Subject: Responses to the NRC questions related to Relief Requests 01-0002-RR and 01-0003-RR

Ambient Temperature Temper Bead Weld Repair
Comparison of Section III/Section XI Code Requirements to 01-0002-RR Methodology

Relief Request 01-0003-RR

Figure 1
Typical IDTB Weld Configuration with Weld Solidification Anomaly

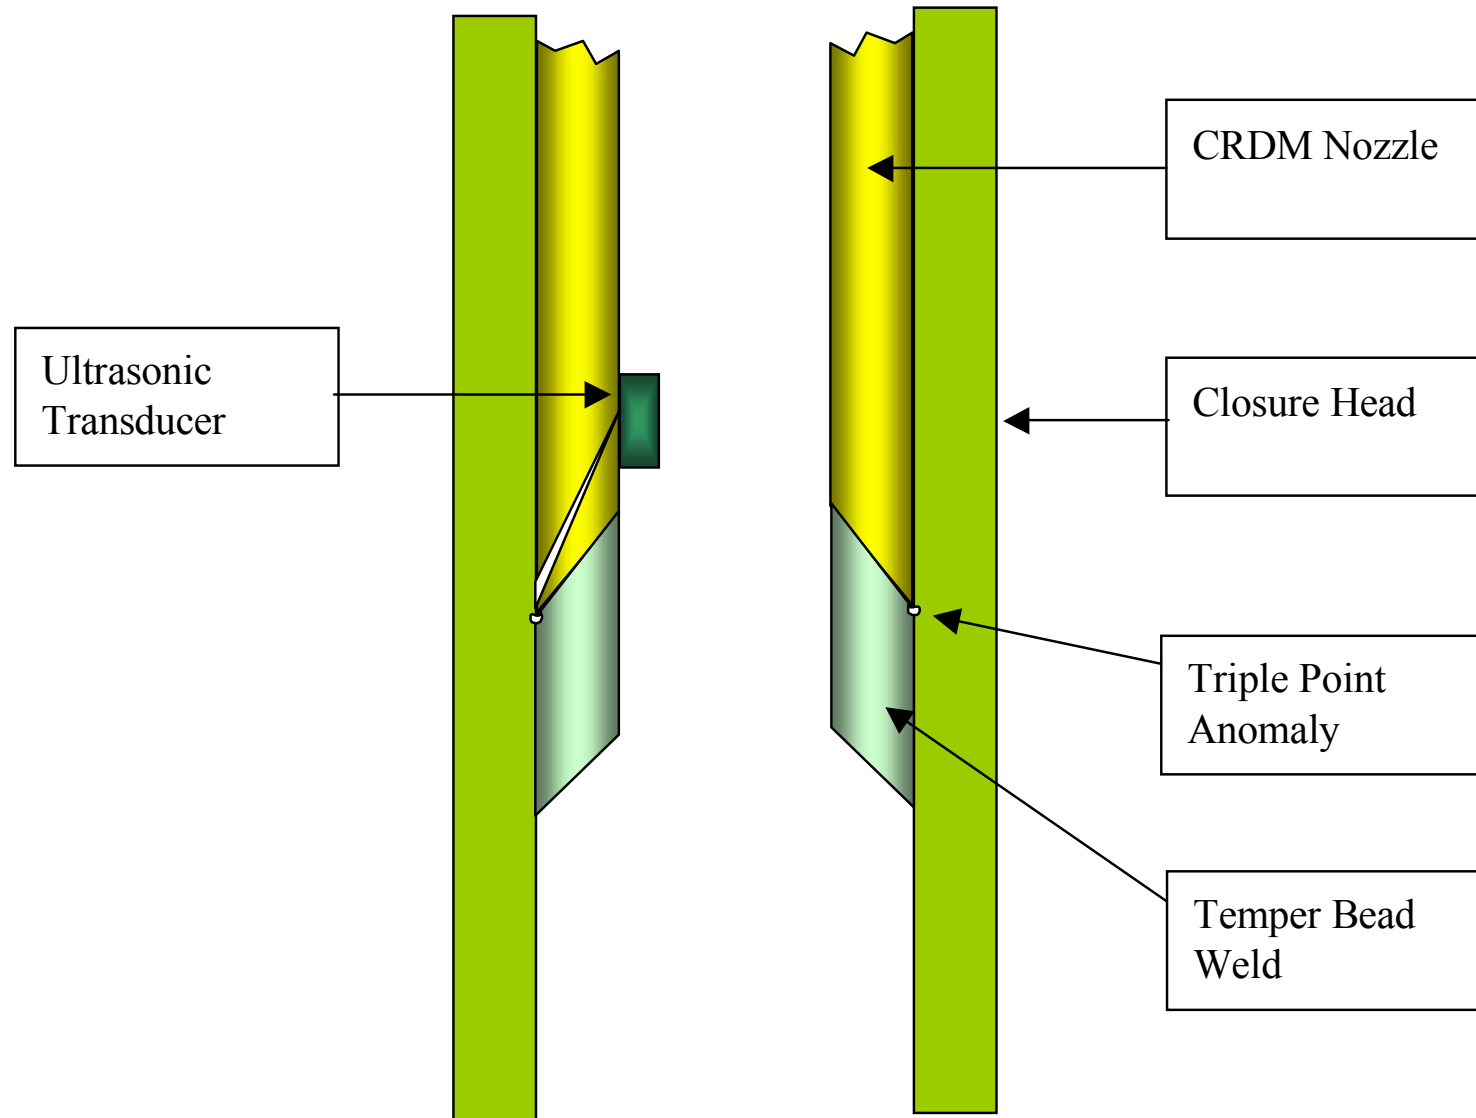
The effectiveness of the UT techniques to examine the ID temperbead (IDTB) repair weld have been qualified by demonstration on a mockup of the IDTB involving the same materials used for repair. Notches were machined into the mockup at the triple point region of depths of 0.10 inch, 0.15 inch, and 0.25 inch in order to quantify the ability to characterize the depth of penetration into the nozzle. This is illustrated in Figure 1. The depth characterization is done using tip diffraction UT techniques that have the ability to measure the depth of a reflector relative to the nozzle bore. Each of the notches in the mockup could be measured using the 45-degree transducer. During the examination longitudinal wave angle beams of 45 degrees and 70 degrees are used (refer to Figure 2). These beams are directed along the nozzle axis looking up and down. The downward looking beams are effective at detecting the anomaly because of the impedance change at the triple point. The 45-degree transducer is effective at depth characterization by measuring the time interval to the tip of the reflector relative to the transducer contact surface. This provides the ability to determine if the anomaly is within the limits of the analyzed 0.10 inch flaw size. The 70-degree longitudinal wave provides additional qualitative data to support information obtained with the 45-degree transducer. Together, these transducers provide good characterization of the solidification anomaly. These techniques are routinely used for examination of austenitic welds in the nuclear industry for flaw detection and sizing.

Detection of the solidification anomaly has also been demonstrated on mockups fabricated during the welding qualification activities. The techniques detected the anomaly and were subsequently sectioned. The anomaly was generally less than 0.03 inch for the samples sectioned.

Figure 2

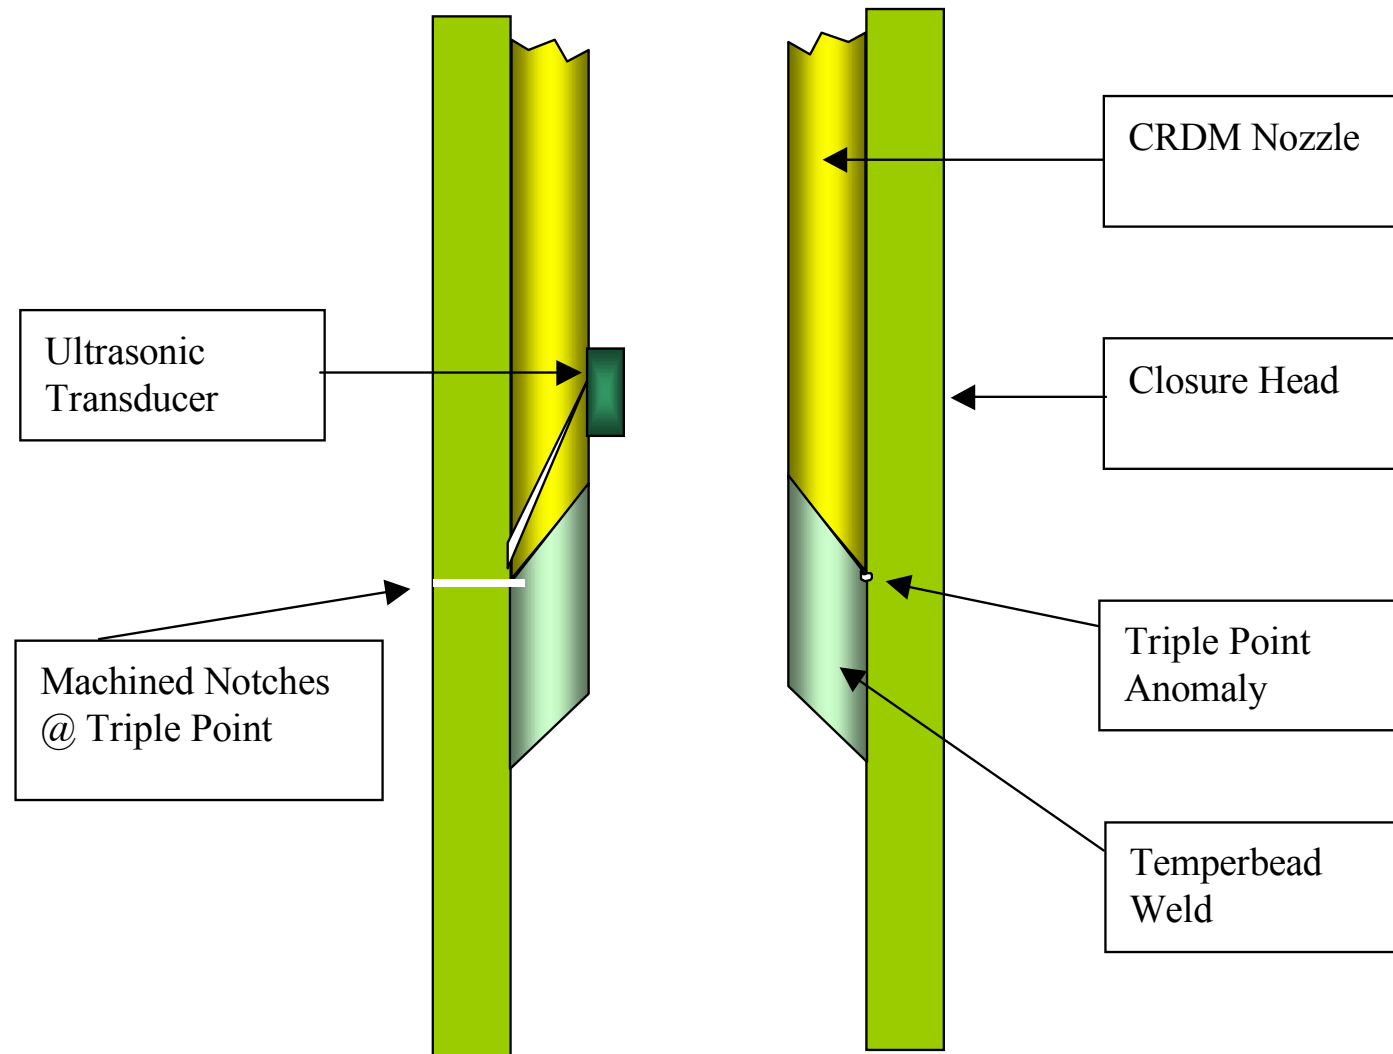
Mockup for Characterization of Weld Solidification Anomaly at the Triple point. Contains notches of 0.10 inch, 0.15 inch, and 0.25 inch depth relative to the OD of the CRDM nozzle. Beam angles of 45 and 70 degrees looking up and down are used.
